Eight Discipline Report (8D Report)

To:	8D report No.:																								
From: Chicony Power Technology	RMA claim No.: N/A																								
CC :	Chicony Power P/N:																								
	Customer P/N:																								
Submit date: 2023/7/14	Product description: 65W PD																								
Receive date: 2023/7/24	Defect D/C or Lot No.:																								
Subject : 客戶 7/14 反應 sample 樣機測試殼溫 fail																									
D1.) 問題解決成員: Use Team Approach																									
主持者 (Team Leader) : Edward Ho 內部成員 (Internal Team Members): <div style="text-align: center;">RD: Will Wu</div> 外部成員 (External Team Member):																									
D2.) 問題說明: Problem Description:																									
(Note: Use who, what, when, where, why, how, how many to specify the Customer's problem.)																									
2023/7/14 客戶告知: 下面為 WM 機種殼溫測試數值，發現 Top 面 ΔT>40 度， Fail 請確認量測的熱點是否不是最 worst ， fail 的部分盡快釐清

CPT 測試 fail 面 : SMD

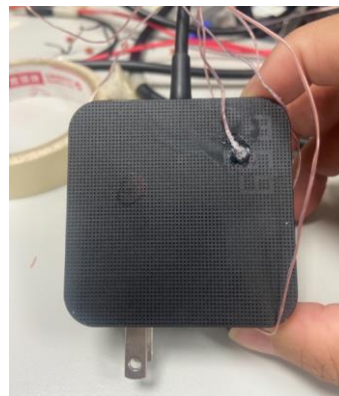
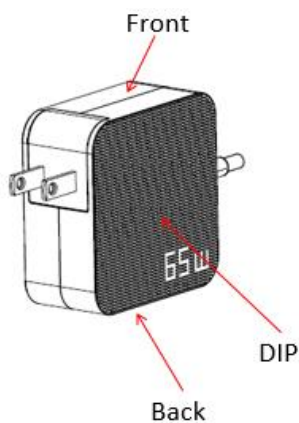
3. 殼溫測試結果，與客戶反應的狀況一致。

客戶測試 fail 面 : Top

Location	Temp (°C)	ΔT(°C)
DIP	60.8	36.6
Front	52.2	28.0
AC	60.1	36.0
DC	61.8	37.7
Back	57.4	33.2
SMD	66.3	42.1
Ambient	24.2

Location	Temp (°C)	ΔT(°C)
Top	67.4	40.7
Right	63.3	36.6
Inlet	62.8	36.1
Output	62.3	35.6
Left	58.8	32.1
Bottom	65.1	38.4
Ambient	26.7

升溫線往水平方向架設

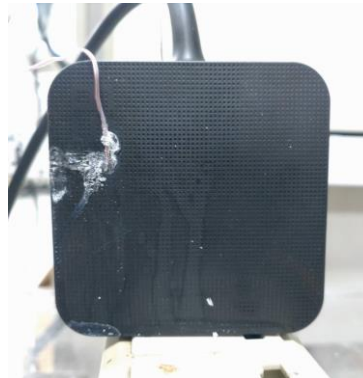
1. 升溫線架設方式驗證：

升溫線架設方式會影響殼溫的測試結果，差異約在 3.7 度左右。

依照結果推估原因，應該是升溫線的感測端垂直平貼熱源，又因熱空氣上升，導致升溫線偵測端受熱，所以偵測的溫度較高。

另外固定升溫線點膠的膠量過多，也會造成升溫線偵測端產生積熱現象。

2. 解決對策：增加 Shielding 和 Case 之間點膠面積

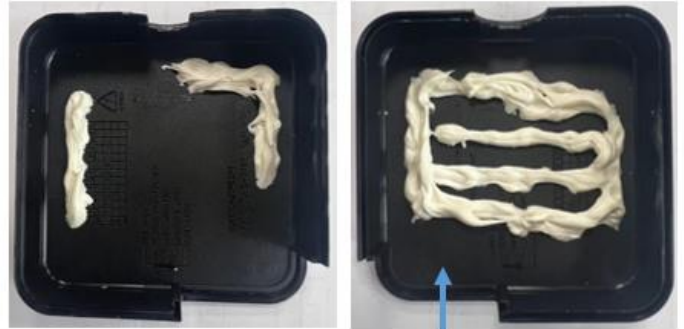
Original

Improved

Only changed SMD side 點膠方式

SMD Side 殼溫改善了7.6度

1. 增加 Shielding 和 Case 之間的點膠面積，並重新驗證殼溫，測試結果均符合客戶規格。
